**TSB 544**  
**June 04, 2019**

## TECHNICAL SERVICE BULLETIN

2019 :: Bay Star

## Shade and Valance Replacement for 2019 Bay Star 3628 (Select Coaches Only)

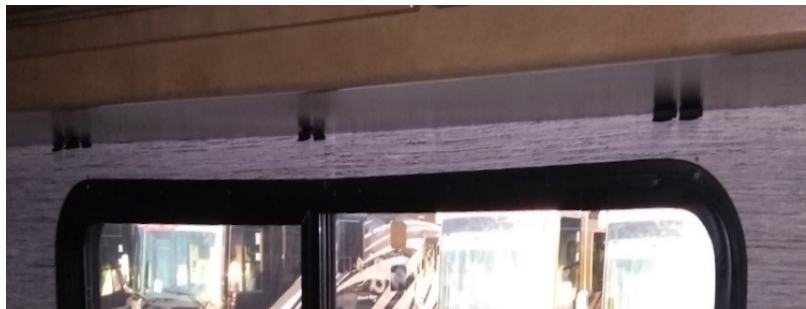
The purpose of this repair is to provide more room between the top of the sofa and the top of window in case an emergency escape is necessary. The fastener mounted shade and valance will be replaced, and the new valance will be clip-mounted and removable.

3. Center the new shade over the window, and mark the bracket location. The brackets should be centered approximately  $2\frac{1}{4}$ " from wall with two brackets near each end and one in the center.
4. Install a  $\frac{1}{2}$ "x3"x53" backer in the overhead cabinet for the shade clips. Pull or pry up the false bottom inside the cabinet, being careful to avoid damage. Glue the backer in the cabinet where the brackets will be placed, and use pin nails to hold it in place. The backer may be cut into shorter lengths if needed.
5. Refasten the false bottom in the cabinet with pin nails.

6. Install the five shade clips to the bottom overhead where marked using  $10 \times \frac{3}{4}$ " screws (part #25756).
7. Install the new shade on the clips, making sure all of the clips are securely latched in the shade.

8. Place the valance, or measure and mark the wall for Friction Catch locations.

Fasten two Friction Catches per side to the sidewall using  $8 \times 1\frac{1}{2}$ " screws (part #42229).

9. Put the valance in place, and secure them to the other side of the Friction Catches using 8x½” screws (part #136072).

The valance is now fastened by four friction catches and can be pulled off if an emergency exit is necessary.
